From: [Brian Lavendel](#)
To: [All Alders](#); [Mayor](#)
Subject: Agenda item 86458--Evergreen, Ohio , and Sommers Avenue Reconstruction
Date: Monday, January 13, 2025 2:53:29 PM
Attachments: [image.png](#)

I'd like to offer a proposed change for the Evergreen Avenue, Ohio Avenue, and Sommers Avenue reconstruction plans (agenda item 86458 of the January 14, 2025 meeting), with apologies for the late notice.

Questionnaire Results

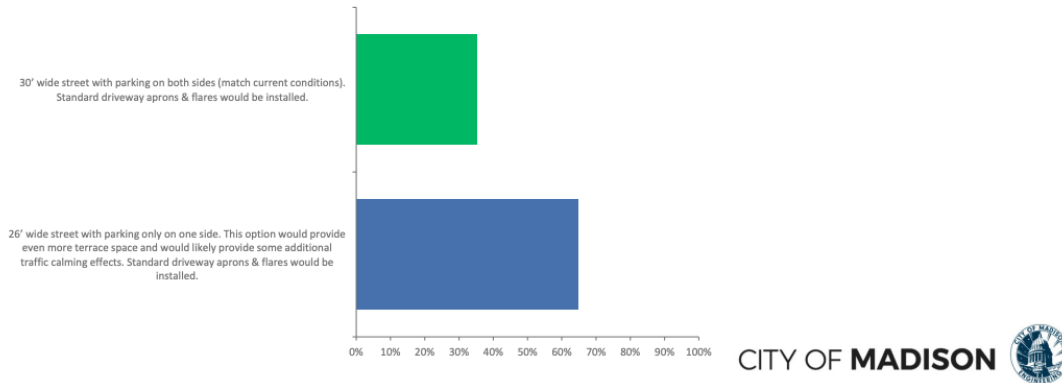
The vast majority of the neighbors are in favor of narrowing Evergreen Avenue, as am I. (See City of Madison Engineering graphic below.) However, three of the five responding households living on Evergreen did not want to lose on-street parking by narrowing the street.

I understand and respect the need for on-street parking and to some extent can understand why engineering chose to go with this 3 to 2 vote of households on the street and keep the street at 30' with parking on both sides rather than the wider neighborhood vote of 26-11 to narrow the street to 26'.

Personally, I disagree and would rather see the broader neighborhood vote respected rather than that of just the 5 households who responded with a very slim 3 to 2 preference for the wider street. That is, a street width of 26' for Evergreen Ave continues to be my preference.

However, there is yet another option--that offers both a slightly narrower street AND maintains parking on both sides.

It seems the solution was not offered because it apparently does not align with the "green streets program." And that is to narrow Evergreen Avenue to 28' AND keep the current parking availability.

I respectfully ask the Council to make this adjustment in the plan to narrow Evergreen Avenue to 28' AND keep the current parking availability. That will meet the overwhelming preference in the neighborhood for a (slightly) narrower street, while also maintaining parking on both sides to satisfy those three households on Evergreen Avenue.
